APPLICATION NO.	FILING DATE	FIRST NAMED INVENTOR	ATTORNEY DOCKET NO.	CONFIRMATION NO.
10/696,208	10/29/2003	Jay R. Walton	010454D1	7298
23696 7590 03/10/2009 QUALCOMM INCORPORATED 5775 MOREHOUSE DR. SAN DIEGO, CA 92121				
EXAMINER				
CUMMING, WILLIAM D				
ART UNIT		PAPER NUMBER		
2617				
NOTIFICATION DATE		DELIVERY MODE		
03/10/2009		ELECTRONIC

### Office Action Summary

10/696,208

**FIG. 12**

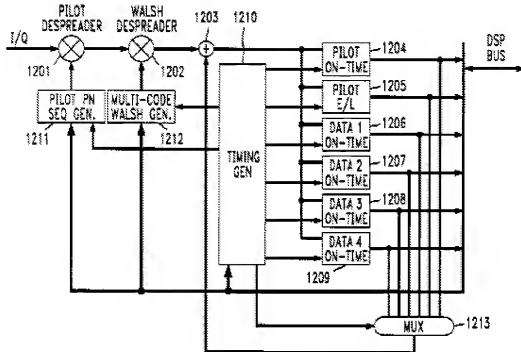
12. Claims 1, 2, 5-8, 12, 13, 15-21, 23-25, 27, 28, and 30 are rejected under 35 U.S.C. 103(a) as being unpatentable over **Huang, et al** in view of **Fasel** as stated in paragraph 3 of the Office action dated October 3, 2008.
